Kathmandu Valley Wastewater Management Project
Kathmandu Upatyaka Khanepani Limited
Project Implementation Directorate
Anamnagar, Kathmandu, Nepal

ADDENDUM NO.2

Contract No.: KUKL/WW/DEWATS/01(ADB Loan No. 3000-NEP (SF))

Construction of Decentralized Wastewater Treatment Plant at Gokarna & Hanumanghat

SCADA System Configuration for Each DEWATS

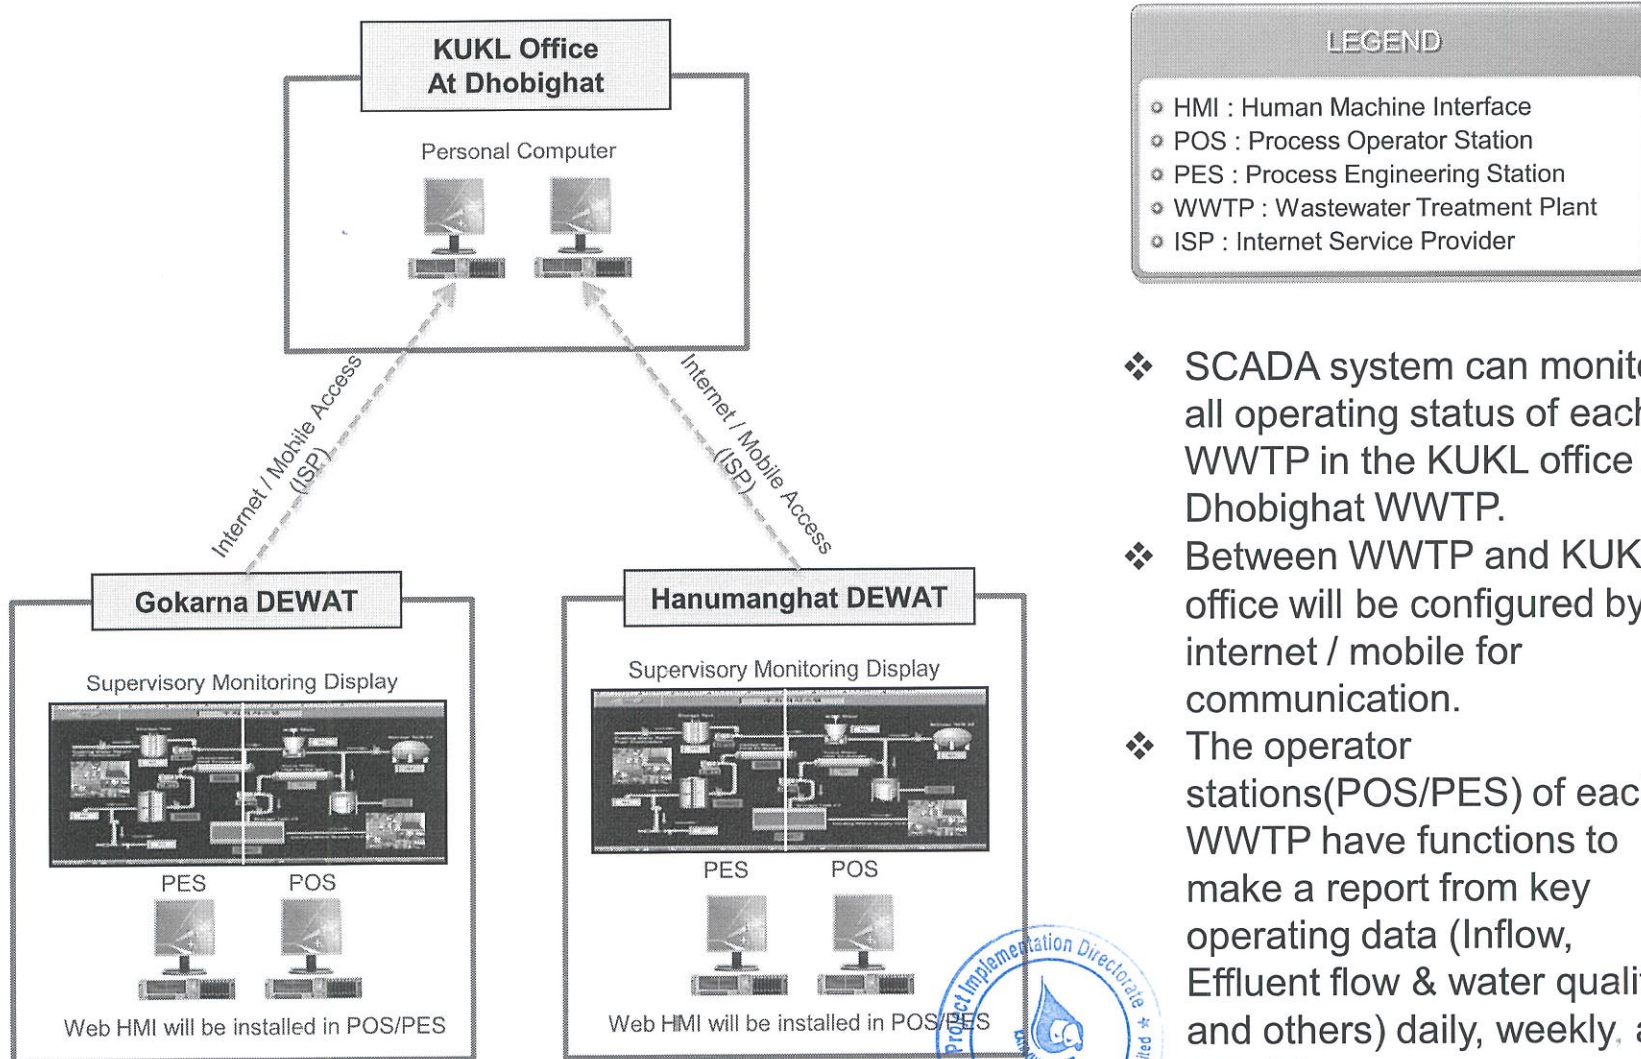
10.		General	Requirement of Solar system, Bio-gas power generation is not mentioned. So we exclude the same.	Solar system and Bio-gas power generation is not applied in the DEWATS.
11	VOLUME II A: Cl: 10.1.3. General requirements	Section-6: Employer's Requirement, Page no. - 6a-179	As bid specification, our understanding, as follows: (i). Bidder shall consider common centralized PLC and SCADA based system for control & monitoring of the entire WWTP process. Kindly confirm. (ii) PLC panel and SCADA system shall be in same premises or separate control Room. Kindly confirm. (iii). Please define the Location of all RCS (remote control station). (iv). Operational data from each WWTP shall be exchanged to KUKL office at Dhobighat WWTP through GSM/GPRS (internet and mobile network) system. Kindly confirm. V) Please confirm the scope to avail telecomm connection from local telecom service company and its monthly rental. (vi). Please provide detail for third party interface with the system.	1) The bidder must install PLC and SCADA systems for each waste water treatment plant (Gokarna and Hanumanghat WWTP) and supply SCADA system for KUKL offices. 2) The SCADA system(POS, PES, Printer and miscellaneous) should be installed in Central Control Room, on the other hand RCS should be installed in the electrical room of waste water treatment plant. 3) For RCS, the bidder must suggest an appropriate location and quantity. (However, all electric load must be monitored and controlled in Central Control Room.) 4) and 5) Communcation service method is currently uncertain, so bidder should propose to transmit data method through the internet or mobile network in consideration of the reliability of communication. 6) Installation of SCADA in Gokarna, Hanumanghat and KUKL offices is a system exclusively for this project, and interfaces with other systems are not considered. * Refer instrumentation Attachment #1 -System configuration diagram

Single Line Diagram at Gokarna

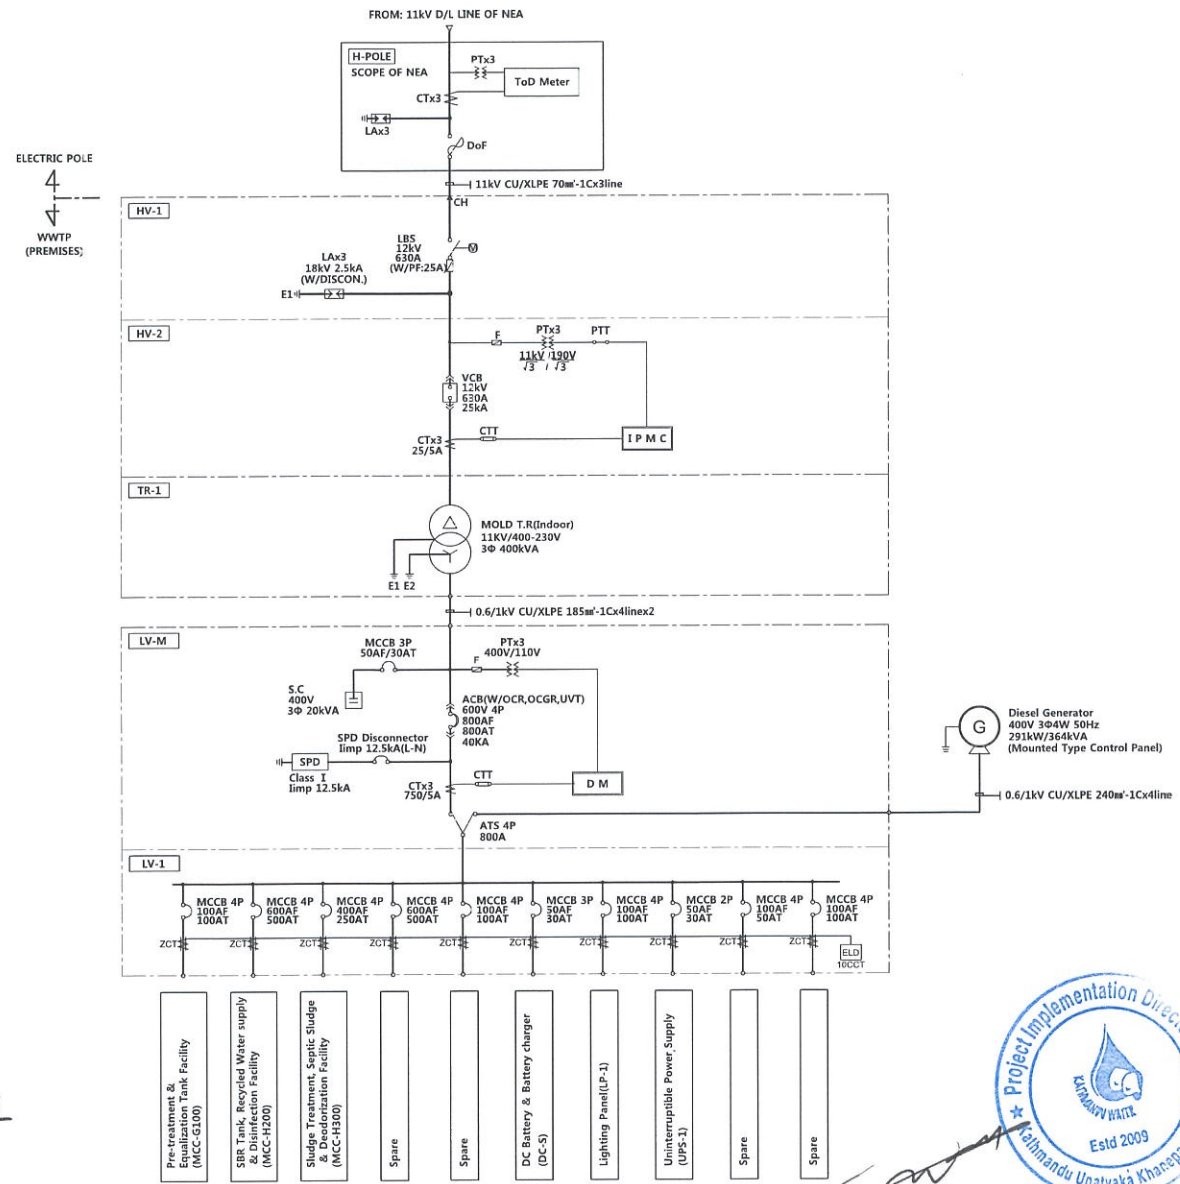
7.		General	Please provide any conceptual SLD if any.	The SLD of schematic design is given in the Appendix of Employer's Requirement for the reference only. Refer to the attached document about the SLD of schematic design. (refer Electrical Attachment#3-1, 3-2)
